**Economic and Social Council**Distr.: General
3 September 2024

Economic Commission for Europe**Inland Transport Committee****World Forum for Harmonization of Vehicle Regulations****194th session**

1958 Agreement:**Consideration of draft amendments to existing****UN Regulations submitted by GRE****Proposal for the 07 series of amendments to UN Regulation
No. 10 (Electromagnetic compatibility)****Submitted by the Working Party on Lighting and Light-Signalling***

Figure 5
Vehicle in configuration "REESS charging mode coupled to the power grid"

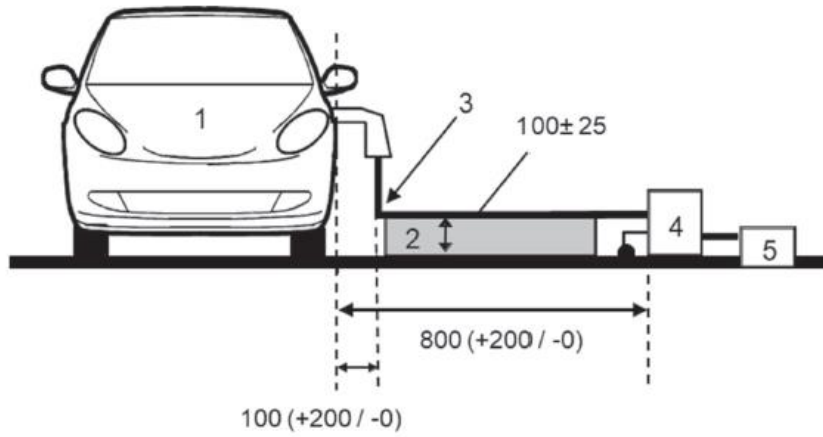
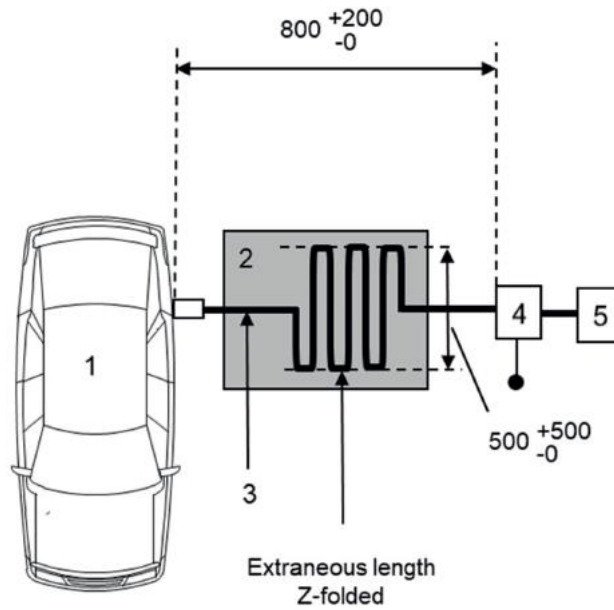
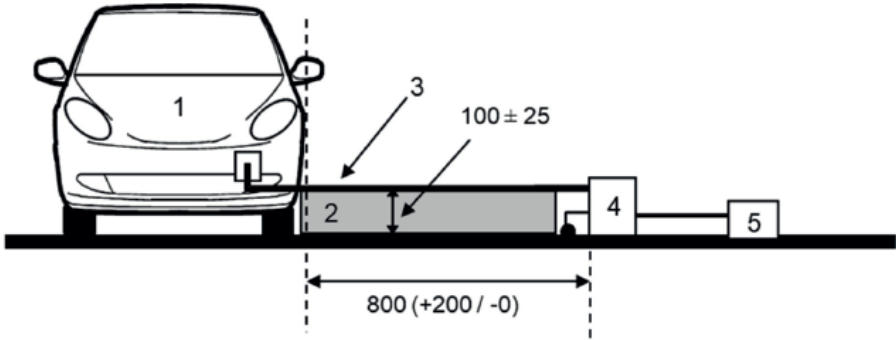
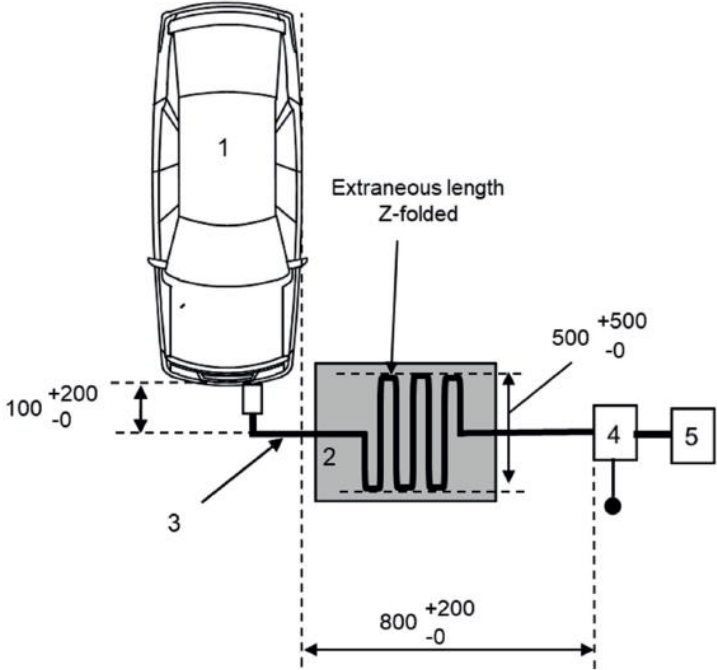
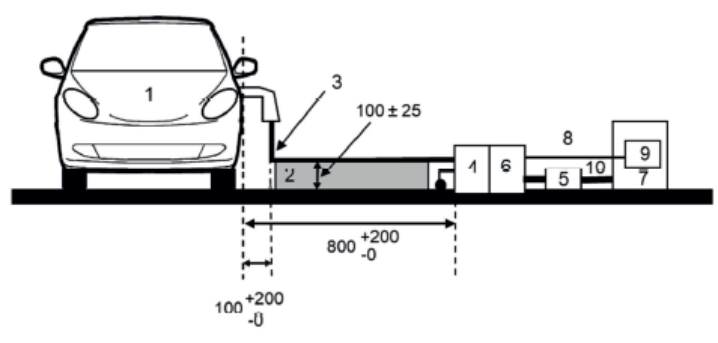
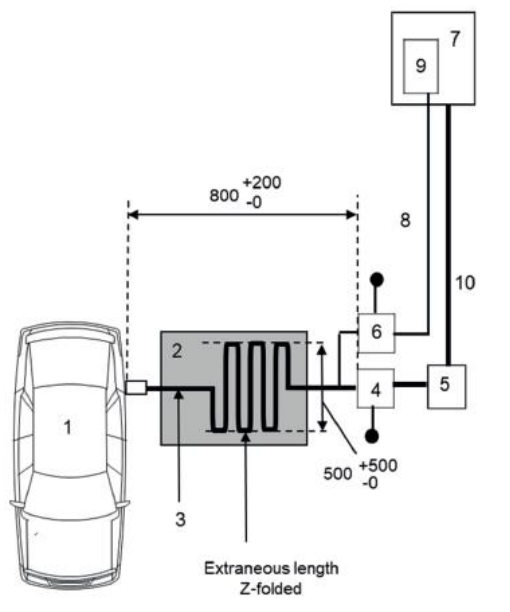
The power charging harness shall be placed in a straight line between the AMN(s) and the vehicle charging plug and shall be routed perpendicularly to the vehicle longitudinal axis (see Figure 5a and Figure 5c). The projected harness length from the side of the AMN(s) to the side of the vehicle shall be 0,8 (+0,2 / -0) m as shown in Figure 5b and Figure 5d.

The power charging local/private communication harness shall be laid out in a straight line between the AMN(s) / DC-charging-AN(s) / AAN(s) and the vehicle charging socket and shall be routed perpendicularly to the vehicle's longitudinal axis (see Figure 5e and Figure 5g). The projected harness length from the side of the AMN(s) to the side of the vehicle shall be 0,8 (+0,2 / - 0) m as shown in Figure 5f and Figure 5h.

The whole harness shall be placed on a non-conductive, low relative permittivity (dielectric-constant) material ($\epsilon_r \leq 1,4$), at (100 ± 25) mm above the ground plane (ALSE) or floor (OTS)."

The whole harness shall be placed on a non-conductive, low relative permittivity (dielectric-constant) material ($\epsilon_r \leq 1,4$), at (100 ± 25) mm above the ground plane (ALSE) or floor (OTS)."

Charging mode configuration for Annex 11

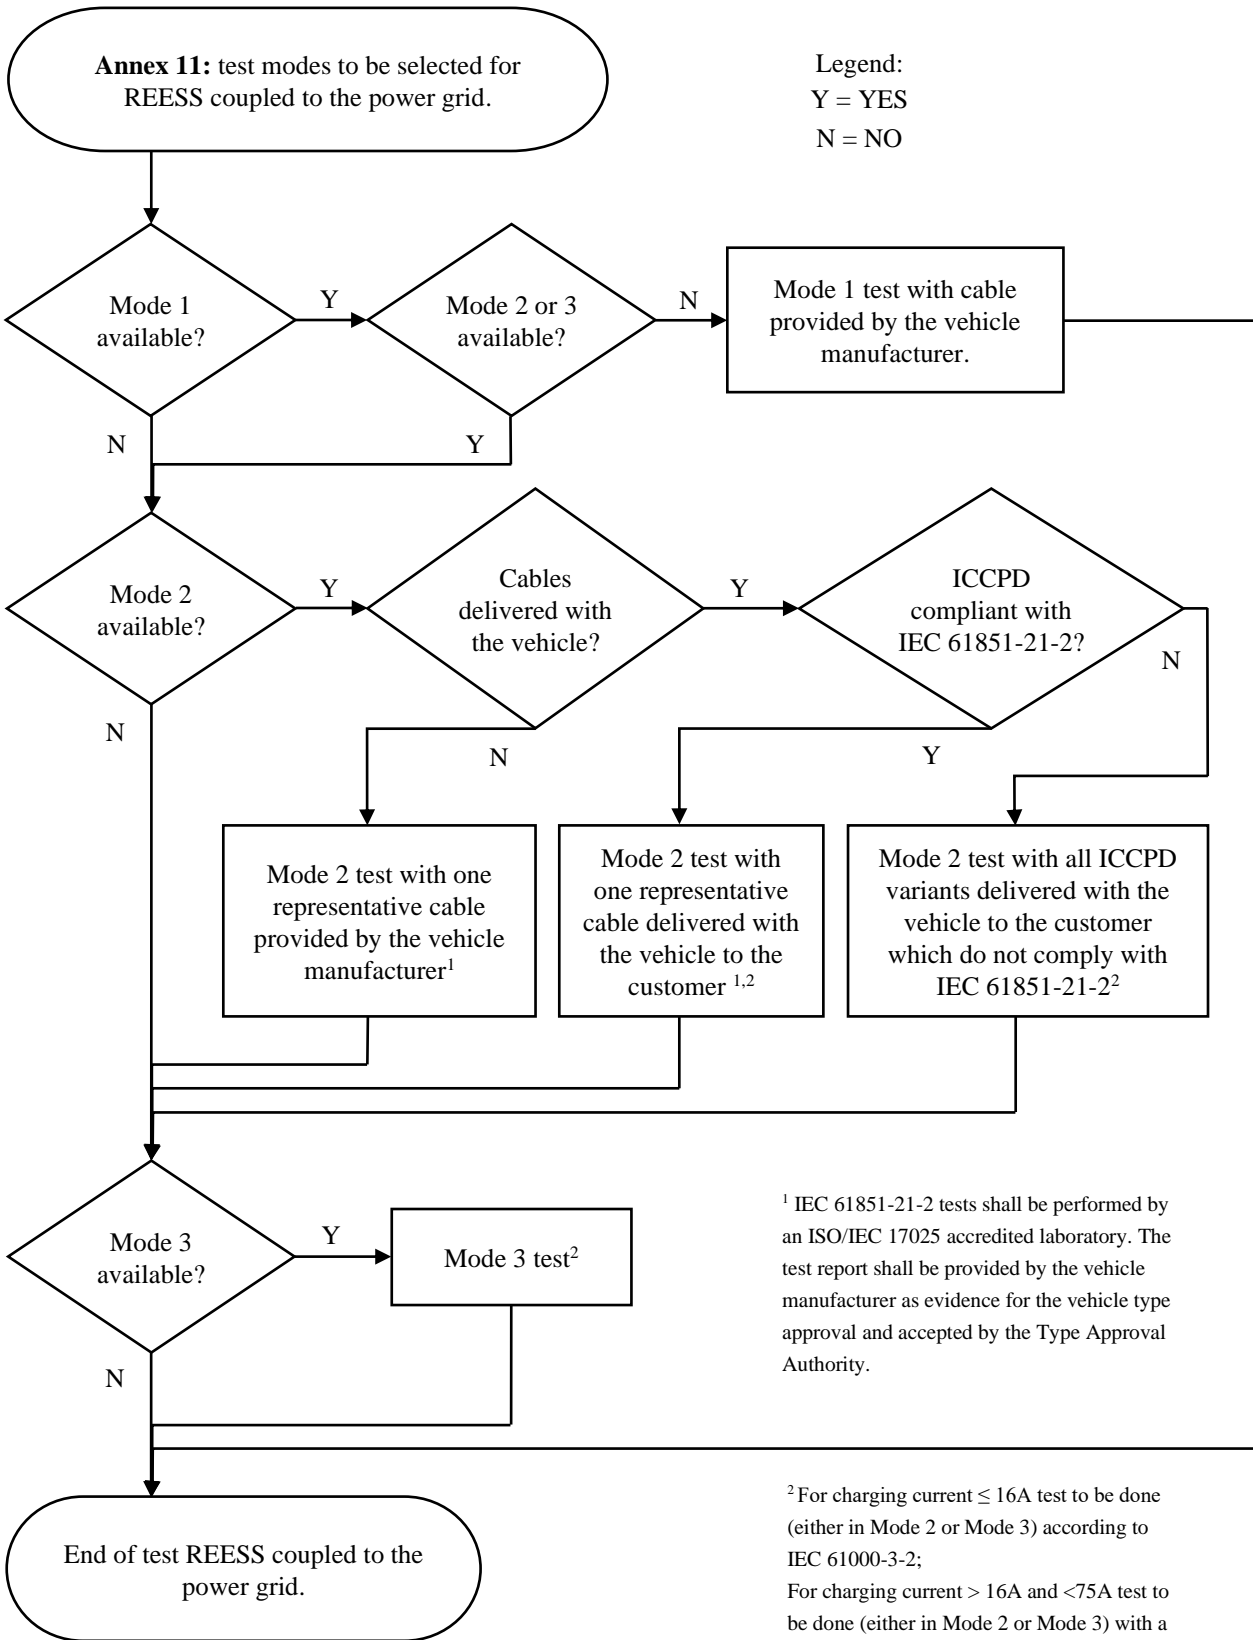
The vehicle shall be tested in the charging mode configuration (if available on vehicle) as defined in flowchart of Figure 1.

The state of charge (SOC) of the traction battery shall be kept between 20 per cent and 80 per cent of the maximum SOC during the whole time duration of the measurement (this may lead to the measurement being splitting into different time slots with the need to discharge the vehicle's traction battery before starting the next time slot). If the current consumption can be adjusted, then the current shall be set to at least 80 per cent of its maximum rated charging/input current value for AC charging.

"Figure 1b

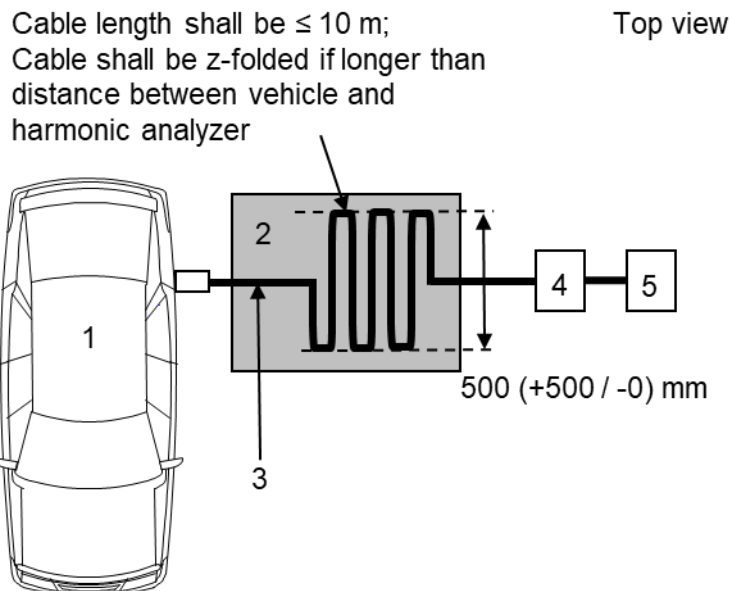
Annex 11, Appendix 1, Figure 1b, amend to read:

"Figure 1d

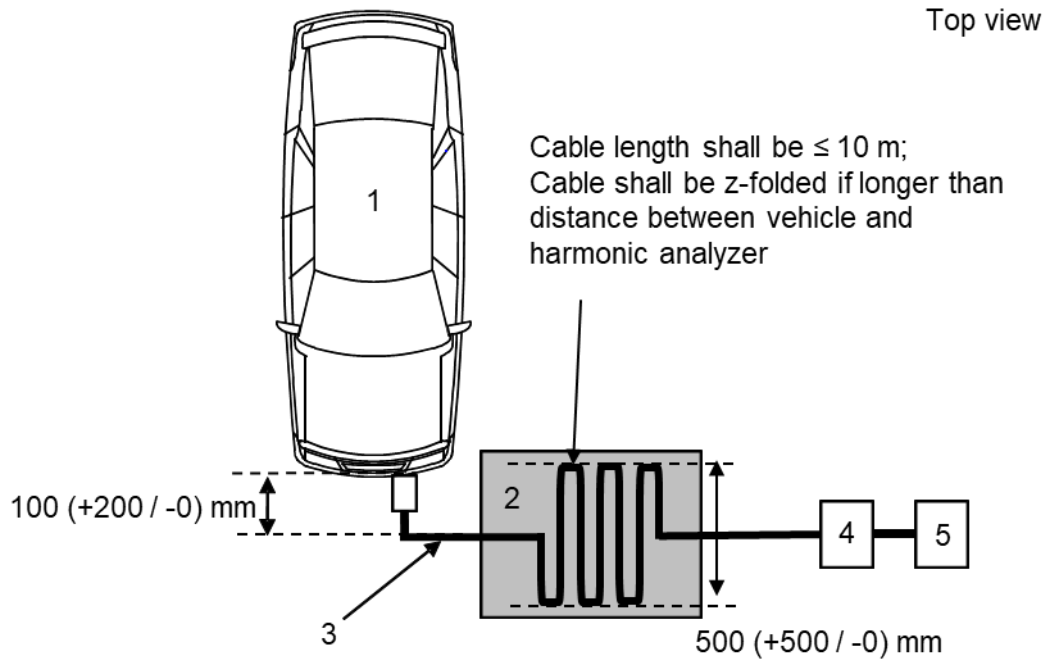
Figure 1d, amend to read:

Charging mode configuration for Annex 12

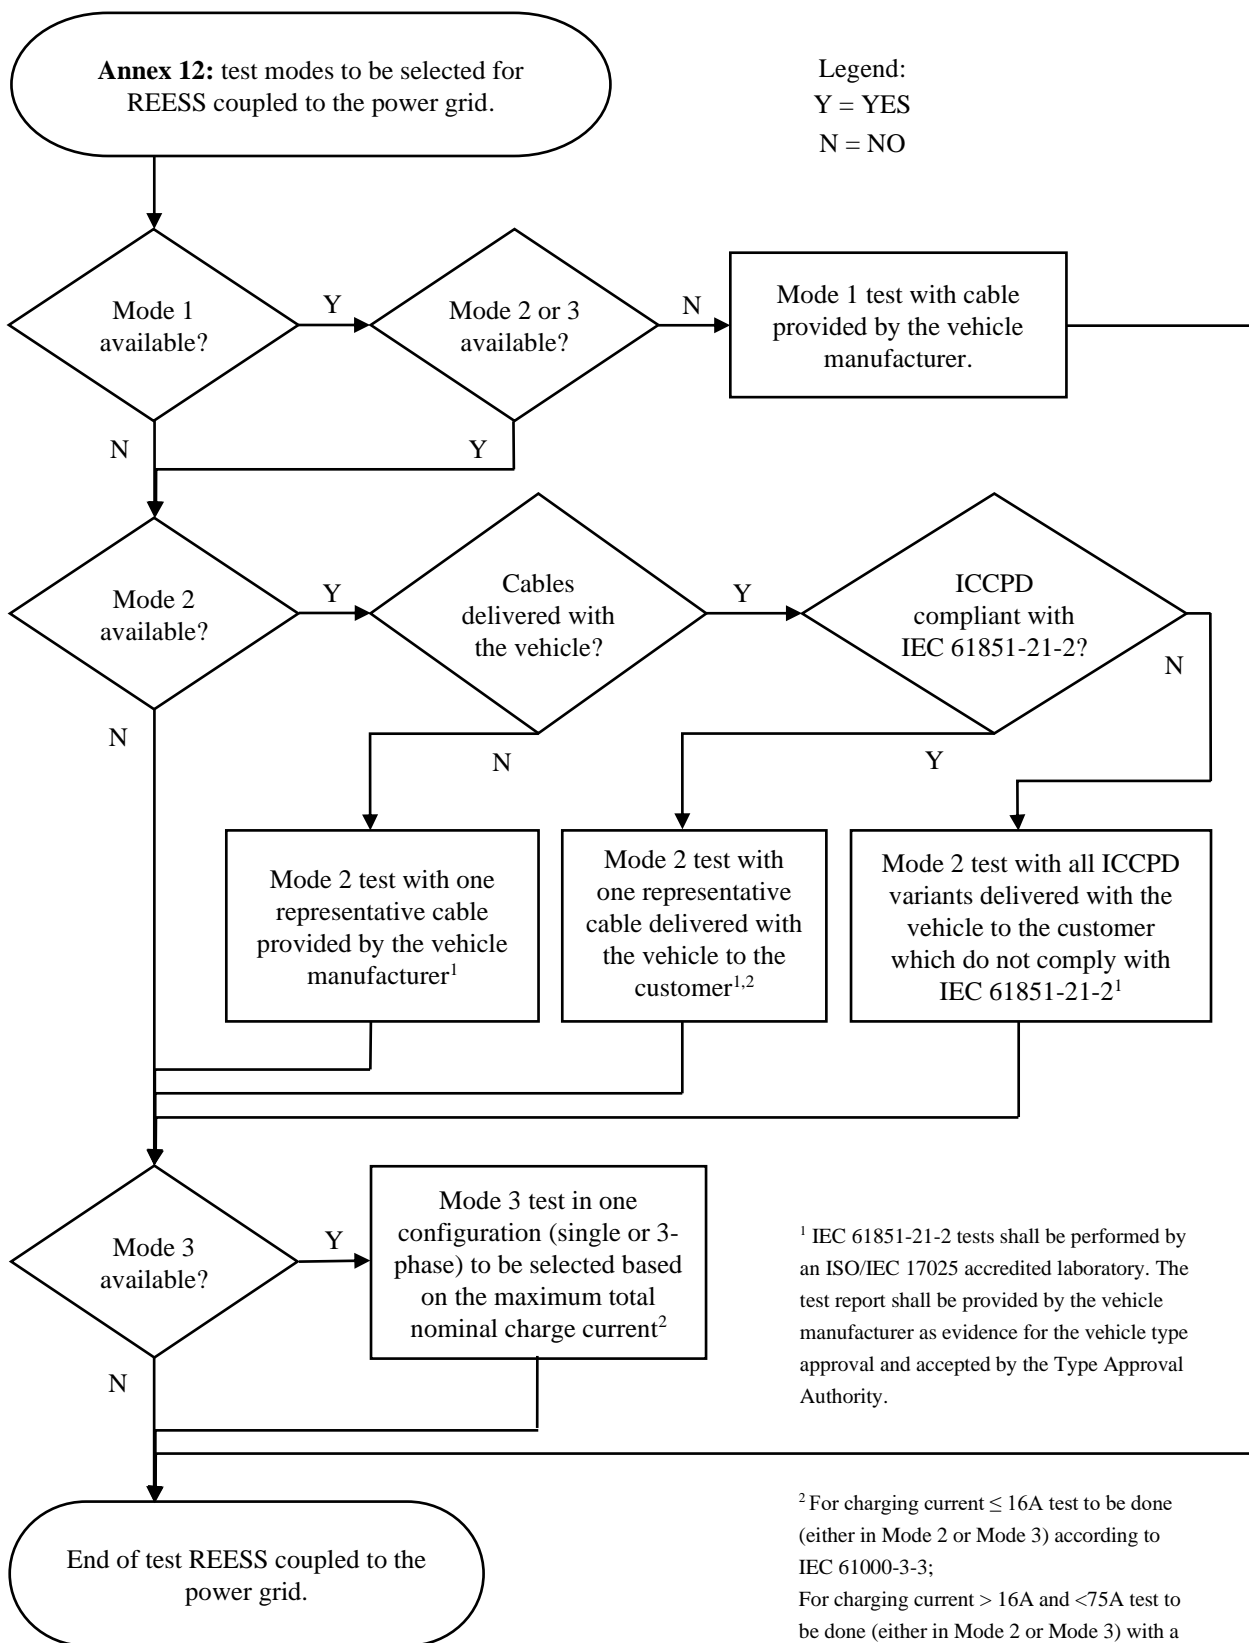
The vehicle shall be tested in the charging mode configuration (if available on vehicle) as defined in flowchart of Figure 1.

The state of charge (SOC) of the traction battery shall be kept between 20 per cent and 80 per cent of the maximum SOC during the whole time duration of the measurement (this may lead to the measurement being splitting into different time slots with the need to discharge the vehicle's traction battery before starting the next time slot). If the current consumption can be adjusted, then the current shall be set to at least 80 per cent of its maximum rated charging/input current value for AC charging.

"Figure 1b

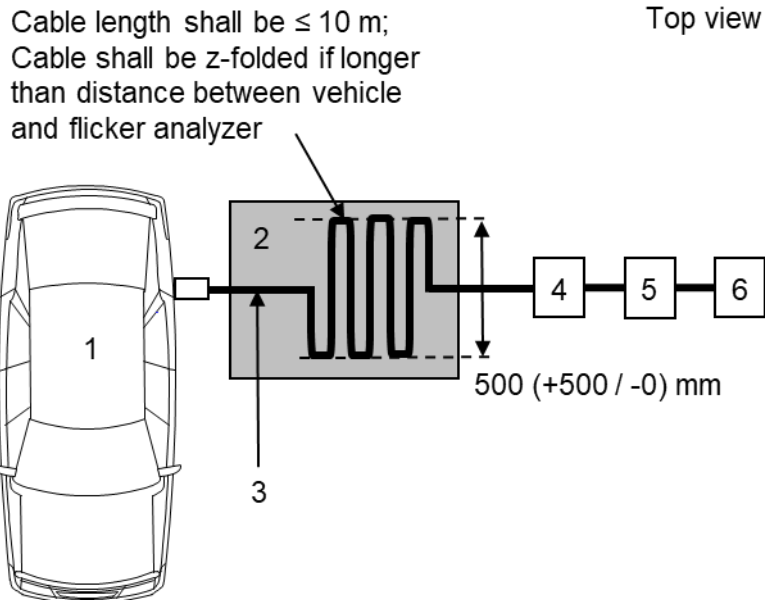
Annex 12, Appendix 1,

Figure 1b, amend to read:

- 1 Vehicle under test
- 2 Insulating support
- 3 Charging harness
- 4 Flicker analyzer
- 5 Impedance simulator
- 6 Power supply"

"Figure 1d

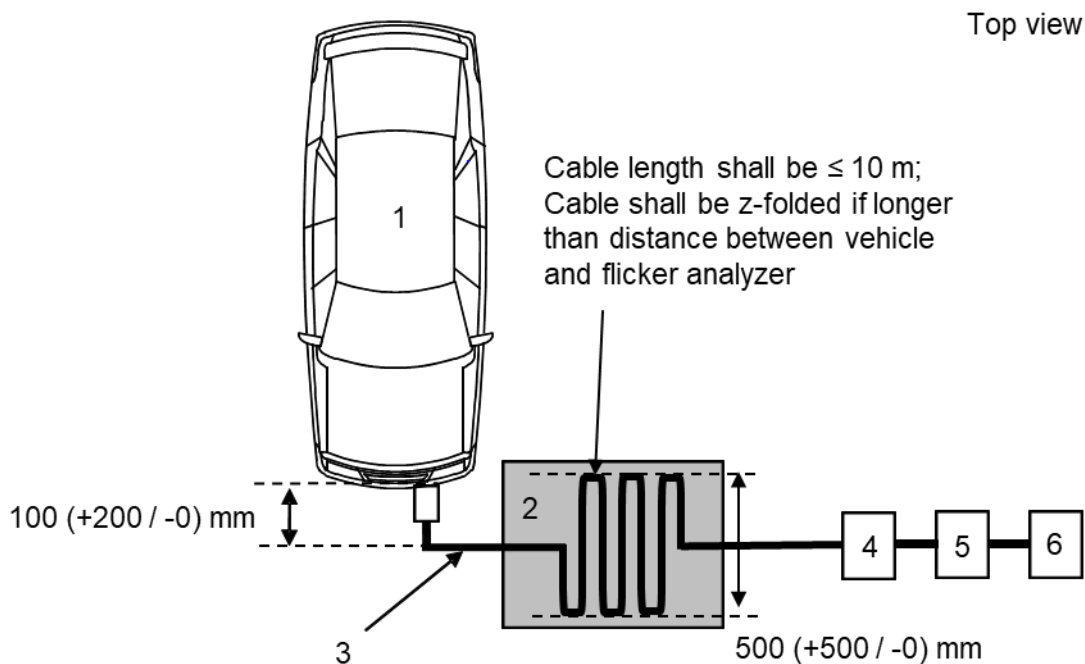
Figure 1d, amend to read:
